2007 - 2013 Corvette: GM TechLink: Low Oil Pressure on V8 Engines

Subject: Low Oil Pressure on V8 Engines

Model and Year: 2007 - 2013 CTS-V, Escalade, Avalanche, Camaro SS, Colorado, Corvette, Express, Silverado, Suburban, Tahoe, Canyon, Sierra, Savana, and Yukon models equipped with a V8 engine (RPOs L20, L77, L94, L96, L99, L9H, LC8, LC9, LH9, LMF, LMG, LY6, LZ1)

Fig. 3

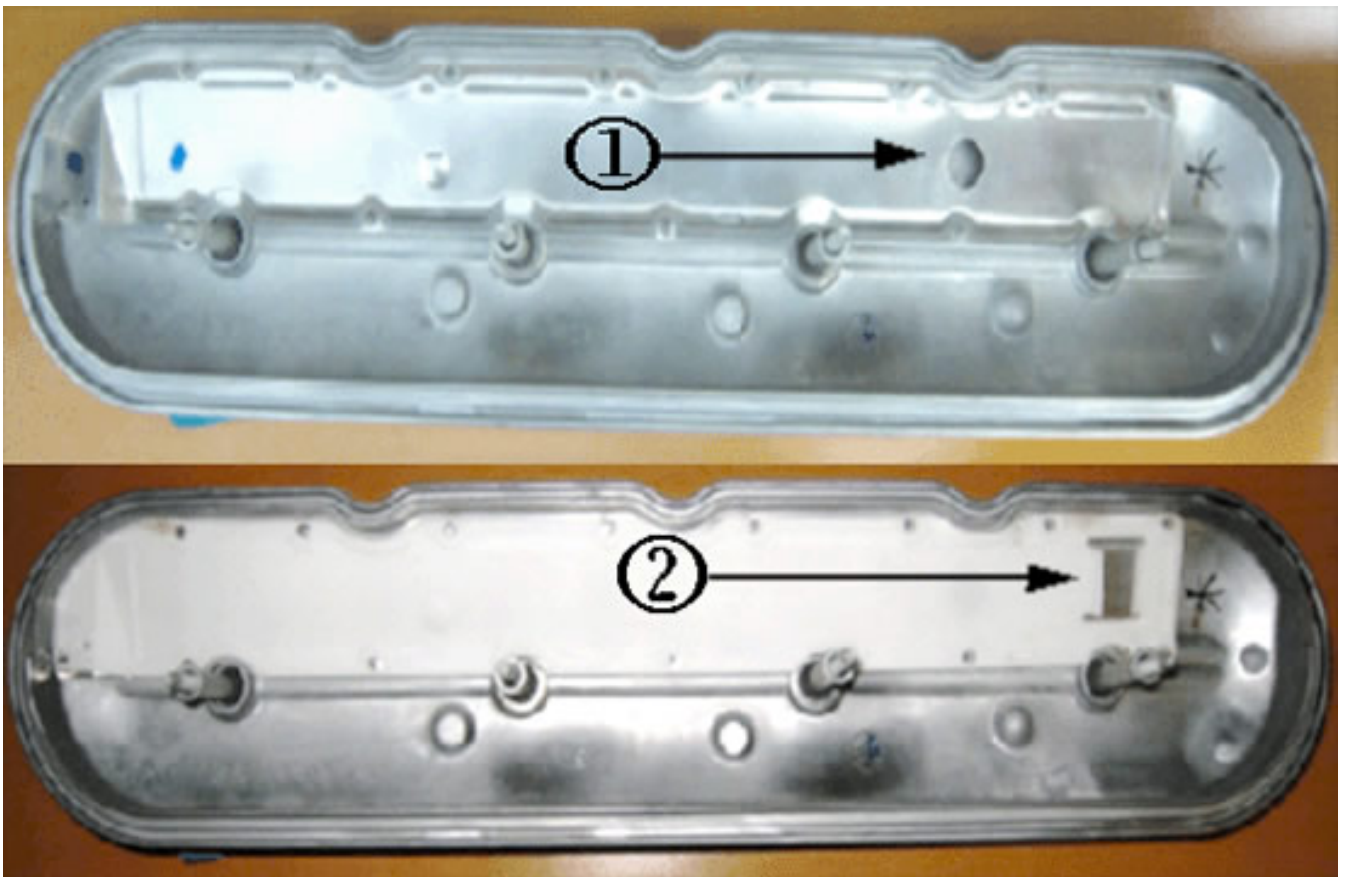
If the engine has been properly repaired and cleaned, inspect the left rocker cover (square baffle) (Fig. 3, #1 – old design; #2 – new design with square baffle) and verify that the baffles can hold water and do not leak. If any leaks

are found, clean and seal the edge of the baffle with RTV, if possible, or replace the valve cover. Thoroughly clean and dry the valve cover before installation and/or resealing.

In addition, change the engine oil and replace the oil filter with a PF48E filter.
